| 12-12-14 | ADDENDUM NO. 4 | |

ASSAWOMAN CANAL TRAIL - PHASE 1
SEDIMENT AND STORMWATER NOTES & DETAILS

SHEET NO.:
C-505

PERMEABLE - ARTICULATING CONCRETE BLOCK (P-ACB) - TYPICAL SECTION

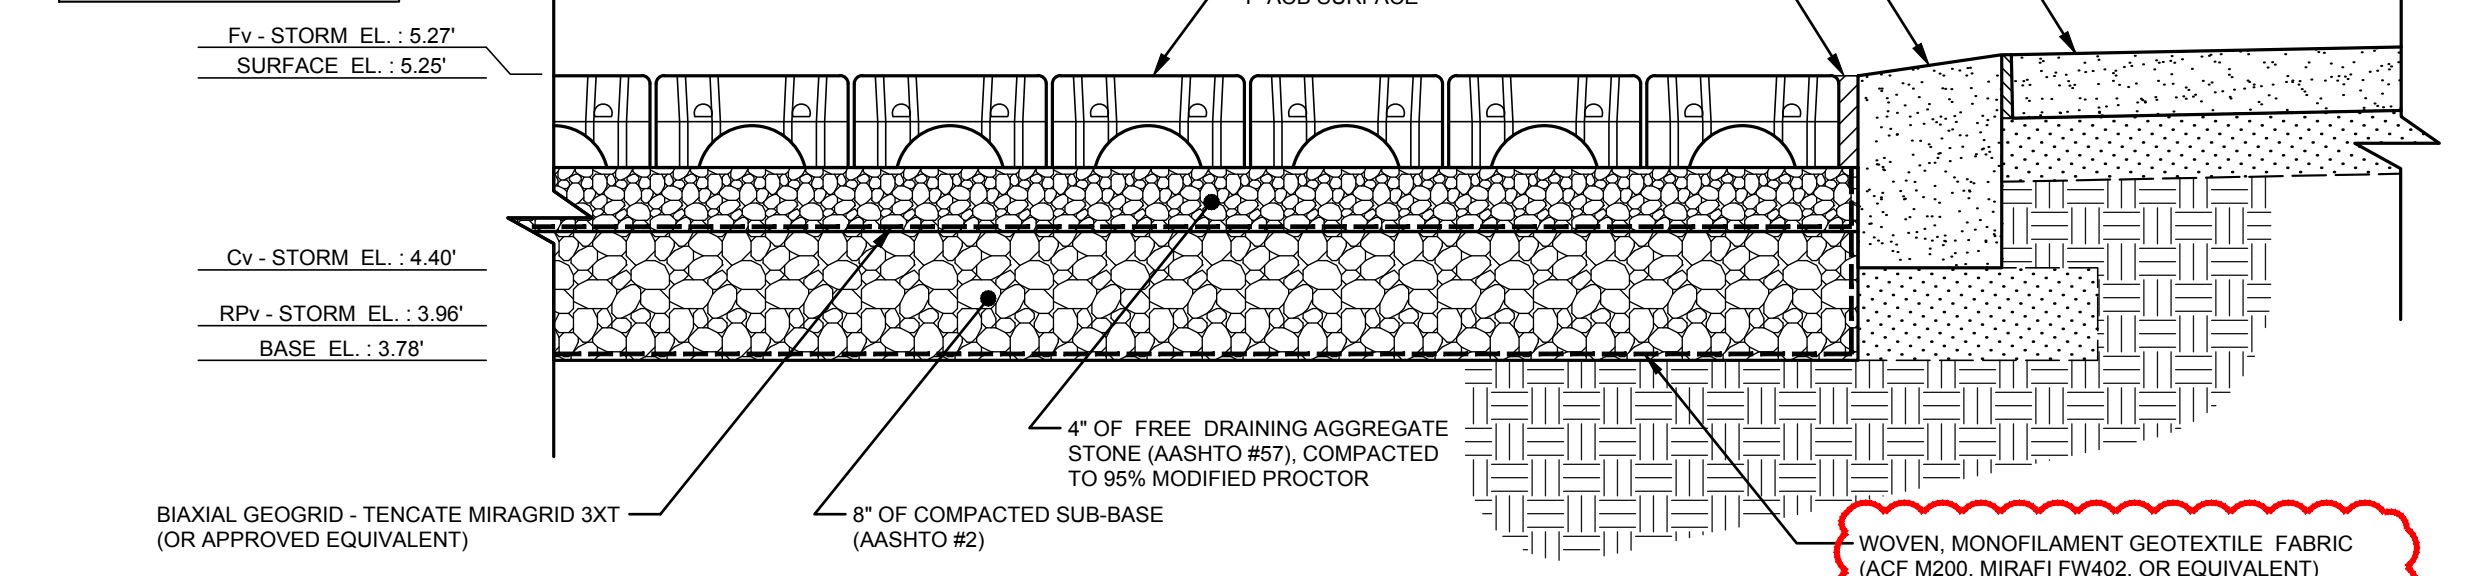
- 4** 1. NON-WOVEN SEPARATION FABRIC REVISED TO WOVEN MONOFILAMENT PER MANUFACTURER'S RECOMMENDATIONS.
